**COMPARK VILLAGE SOUTH  
F1 AMD 2 - MULTIFAMILY  
SITE PLAN**  
LOT 2, COMPARK VILLAGE FILING NO. 1, AMEND NO. 2  
SOUTH HALF SECTION 6, TOWNSHIP 6 SOUTH, RANGE 66 WEST OF THE 6TH PRINCIPAL MERIDIAN  
TOWN OF PARKER, COUNTY OF DOUGLAS, STATE OF COLORADO

**TYP CARPORIT ELEVATION & PLAN**

**A1-00**

**MATERIALS**

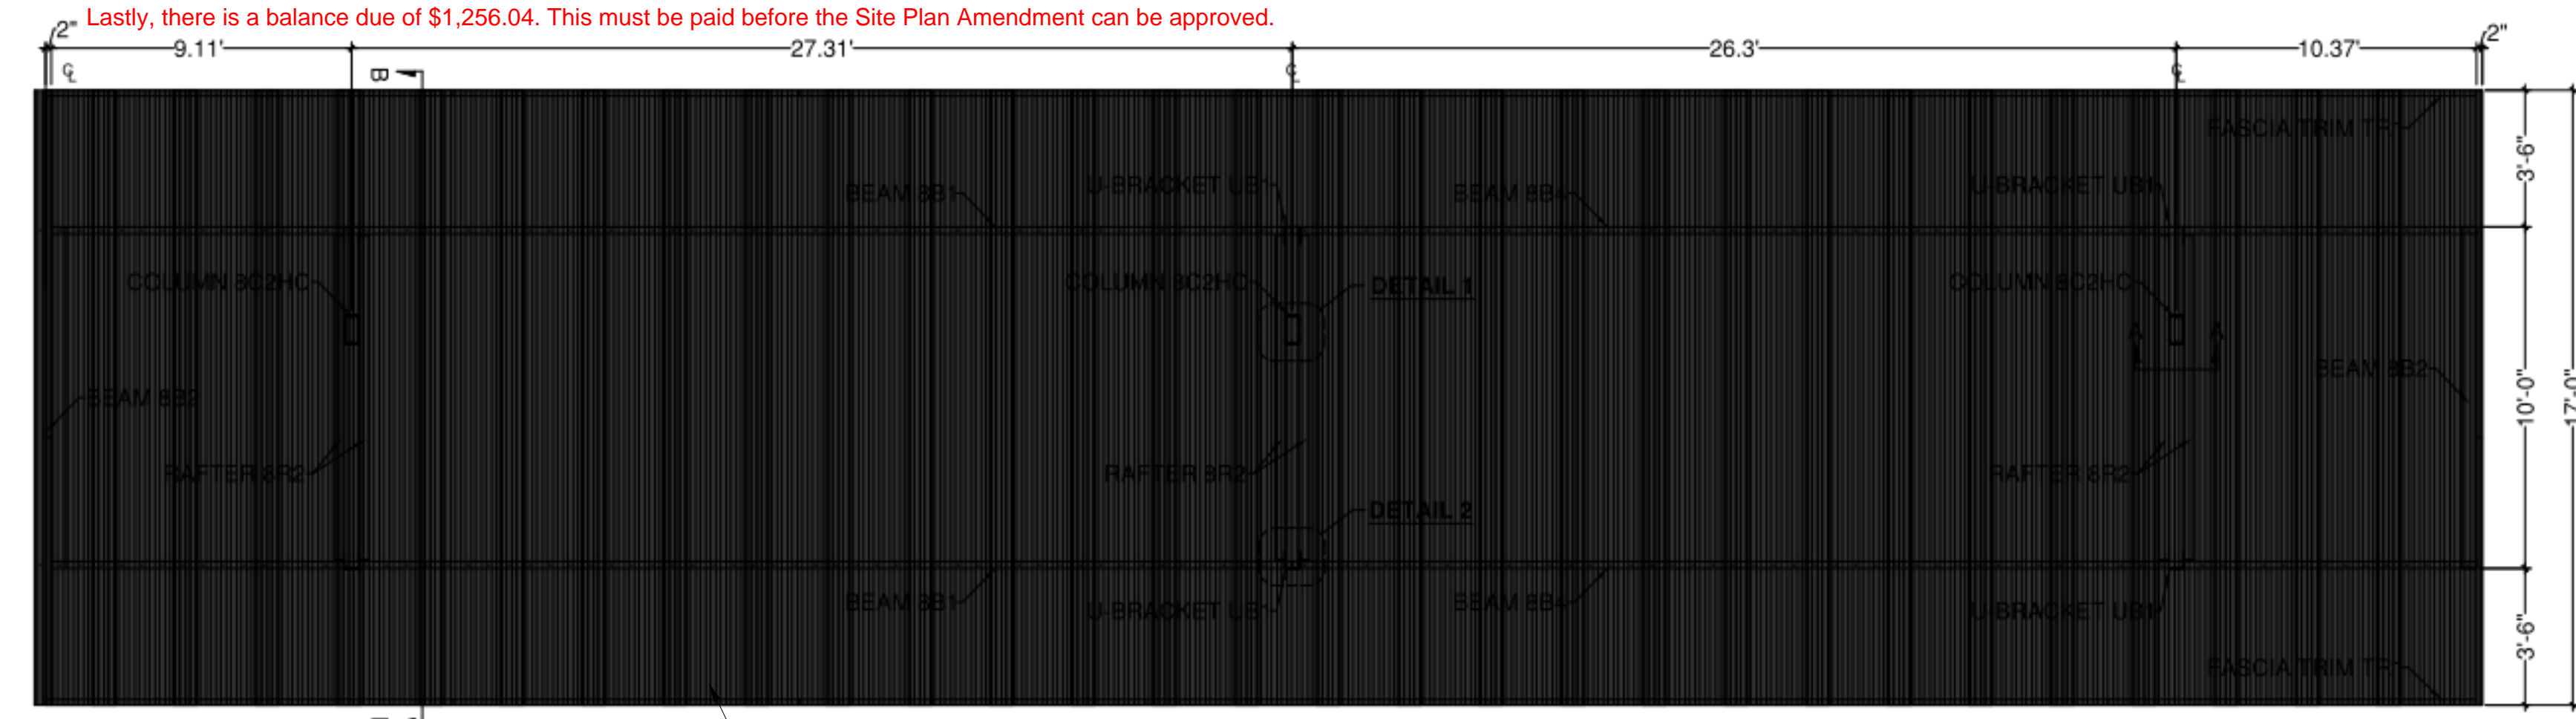
Staff appreciates the addition of the notes regarding the color of the carport structure. However, staff does not see where the material is stated. In the last email from Sean Palmer the material was identified as 'steel' but this material information needs to be added to this sheet.

CARPORIT #3 ROOF PLAN, TYPICAL FINISH

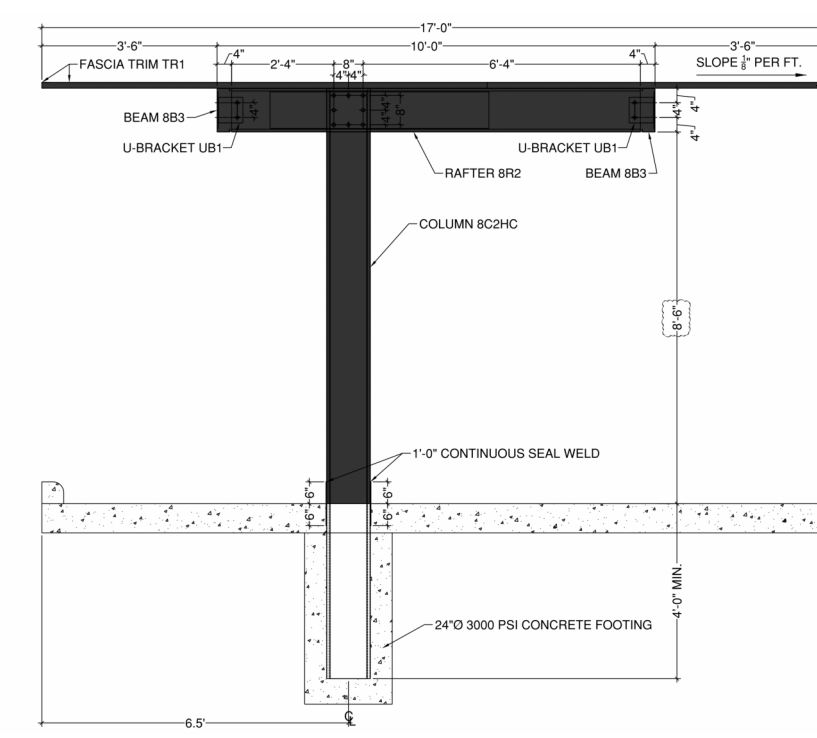
The roof plan that has been added doesn't really show how the roof will look. Is it flat, corrugated, etc. Please provide a description or a clearer depiction.

CARPORIT #3 SIDE ELEVATION, TYPICAL FINISH

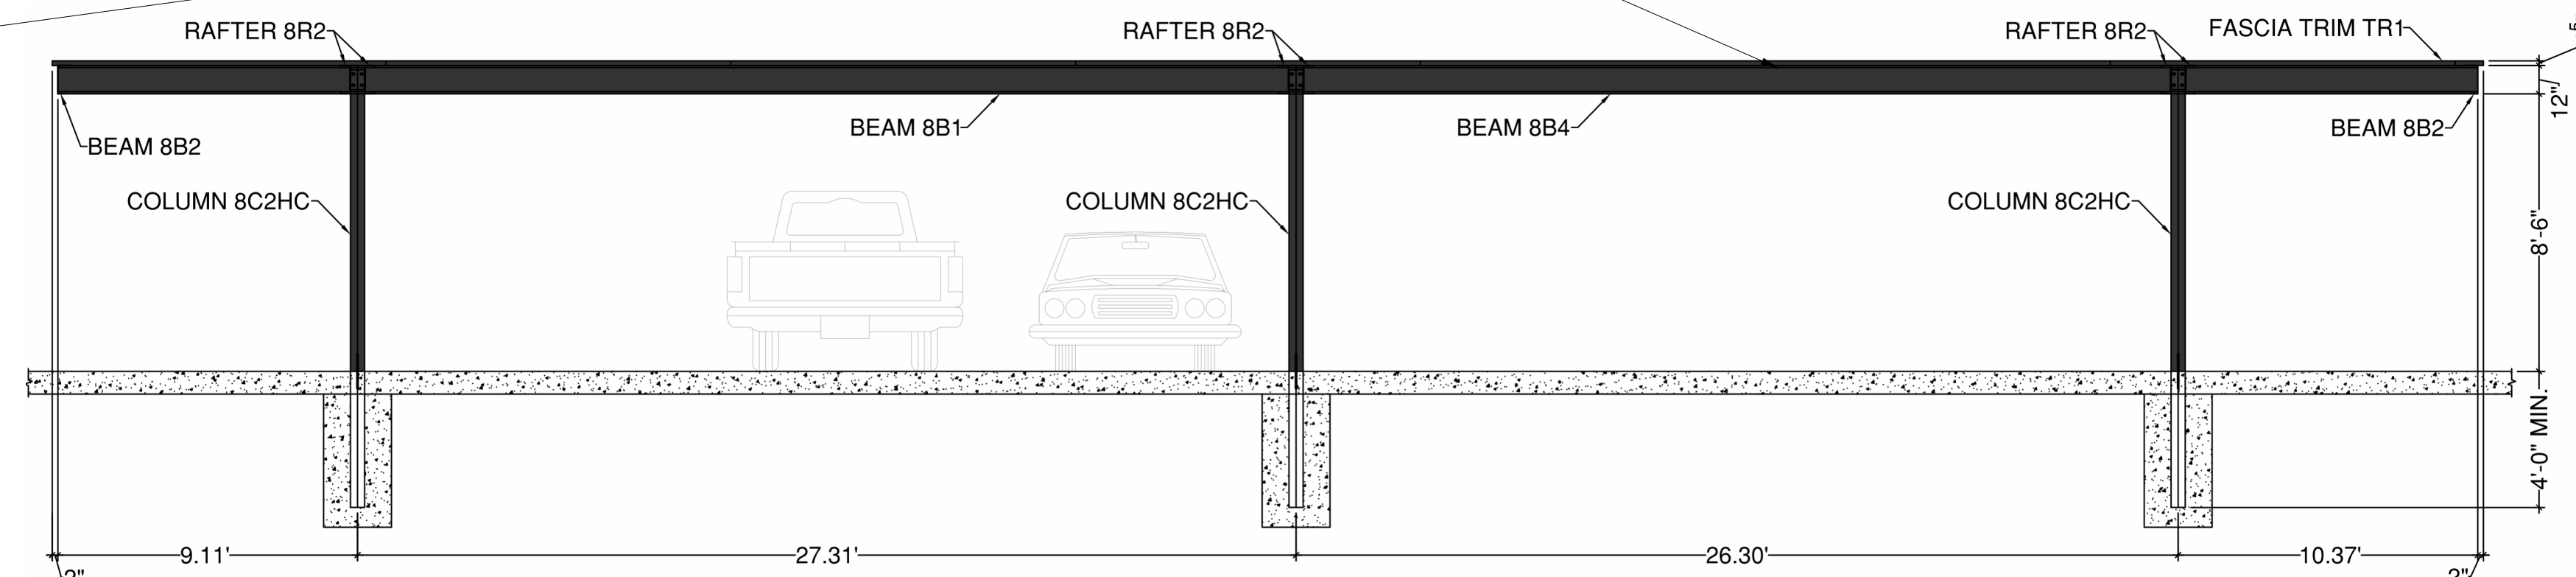
Please articulate how the carports integrate with the buildings. Staff has added some language as an option for accomplishing this. You may have another idea, but these things need to be clear on the drawing itself.
